**DRAWING OF
OUR GROUND-
LEVEL SETUP
HERE.**

Bell Mounting Assembly

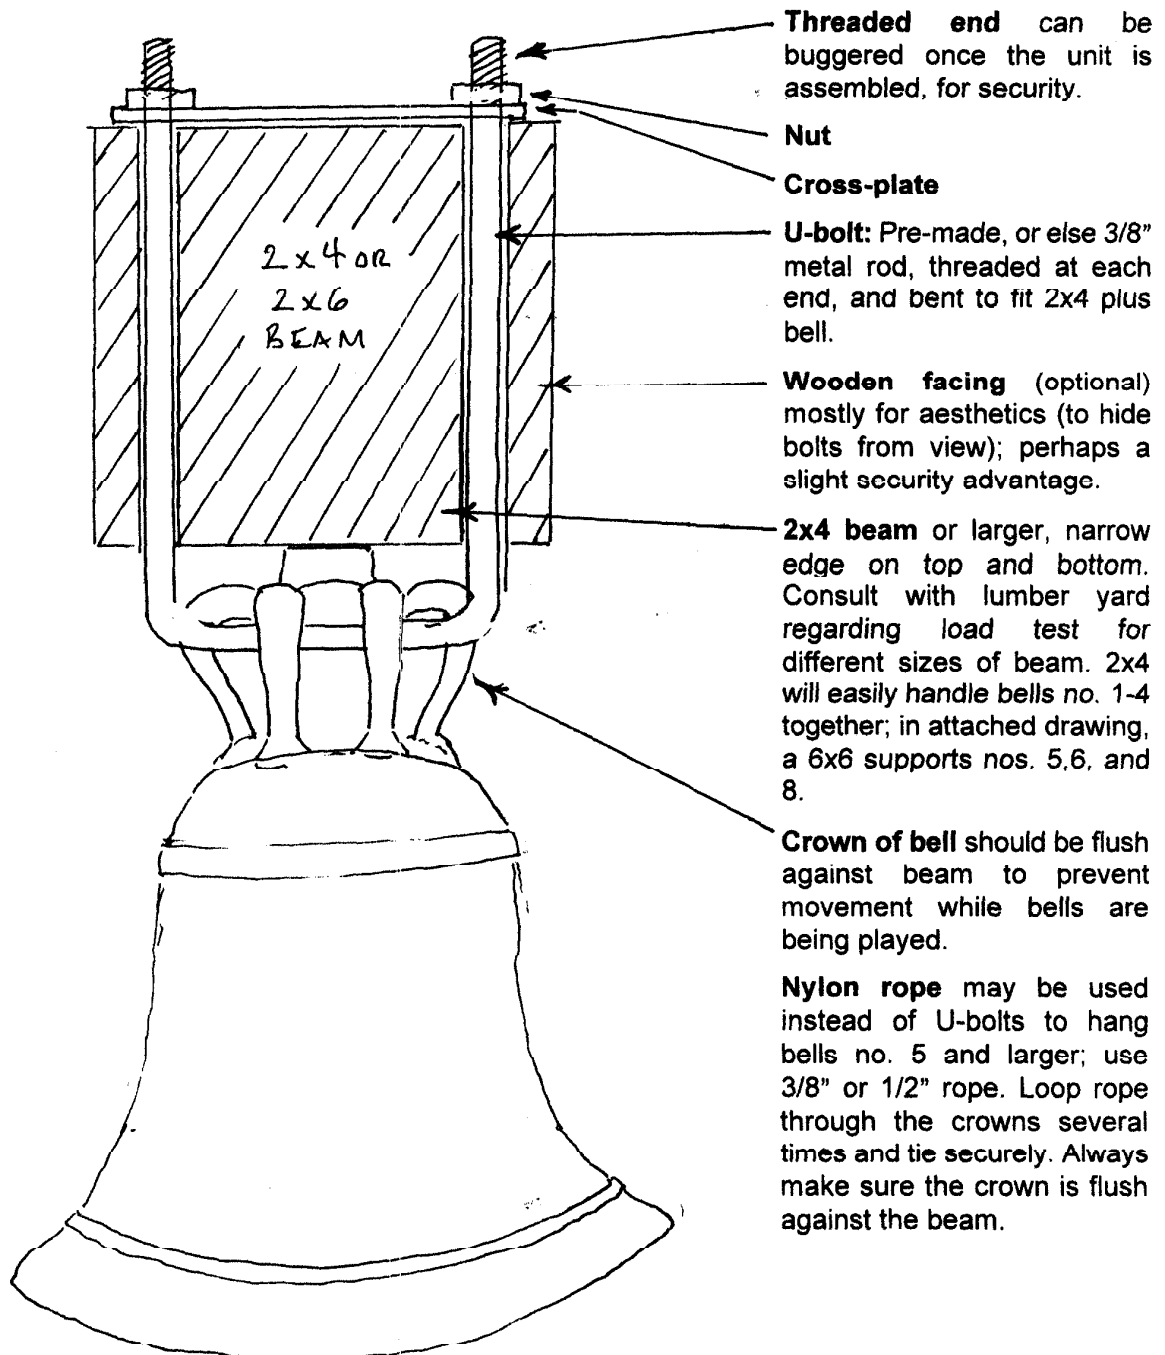
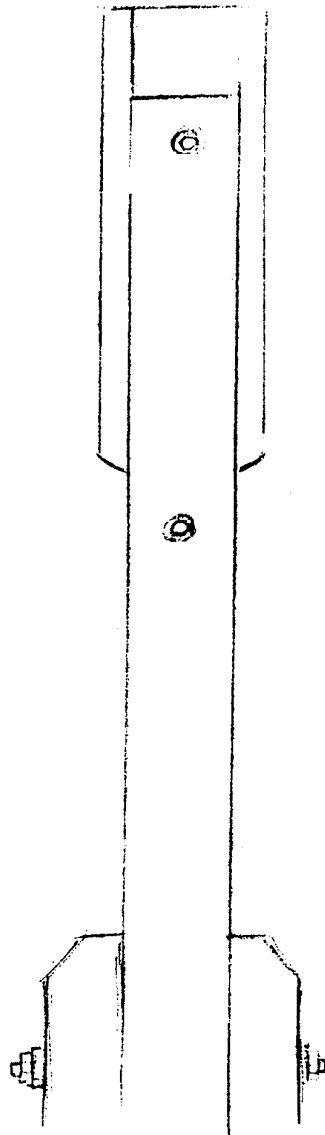
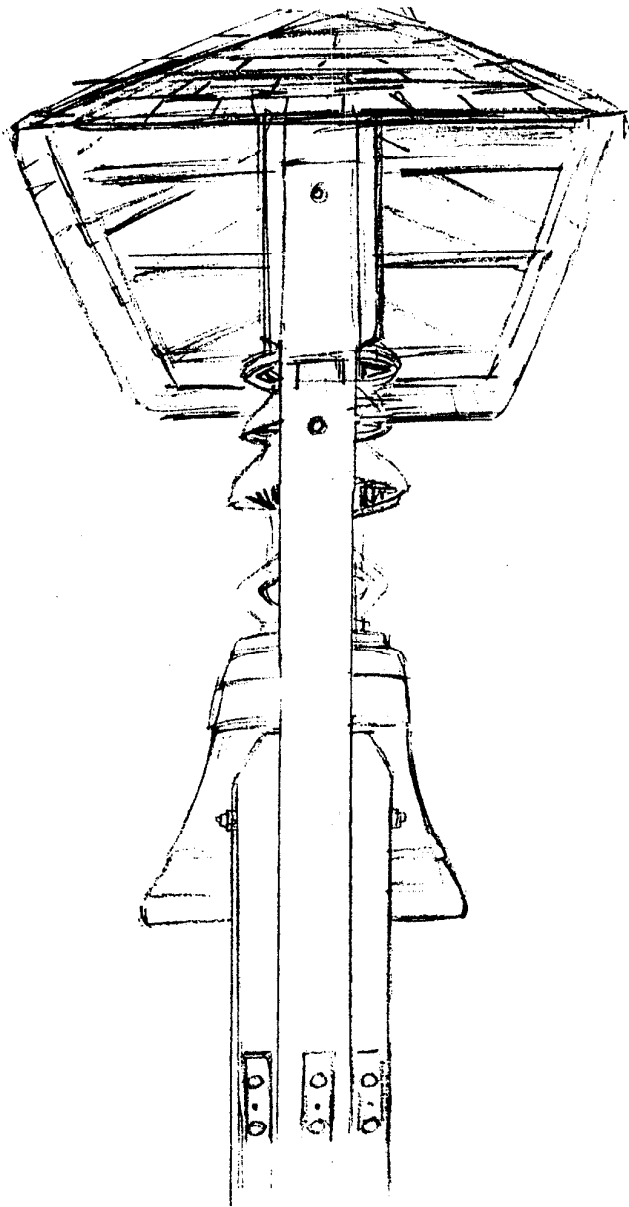
NOT SHOWN
CORRECTLY!
CROWN SHOULD
BE FLUSH AGAINST
BEAM!

The crown of each bell should be snug
against the beam from which it hangs.

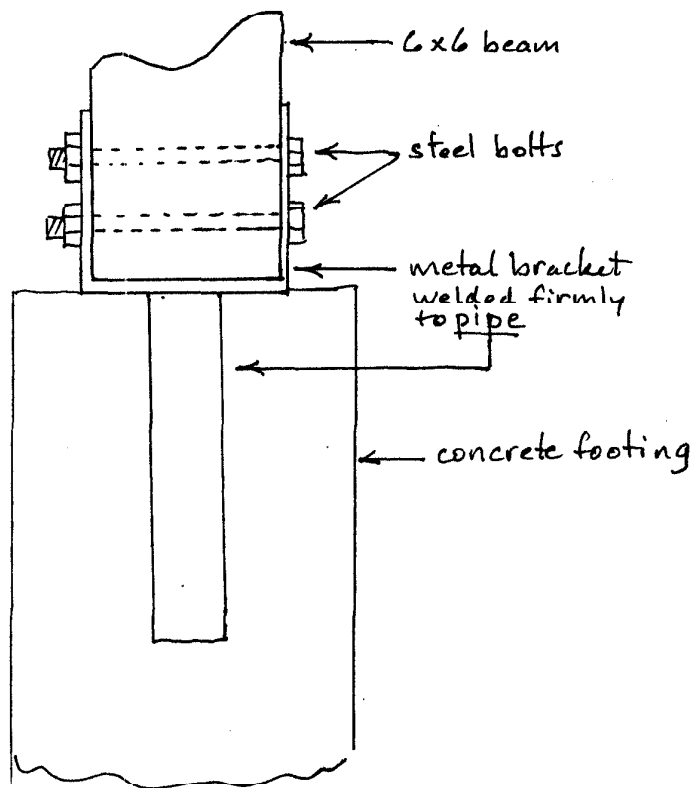
Our setup is actually only 1' wide, but I noticed Holy Myrrhbearers made theirs about 3' long, at a right angle to the zvonitsa frame.

Good idea!
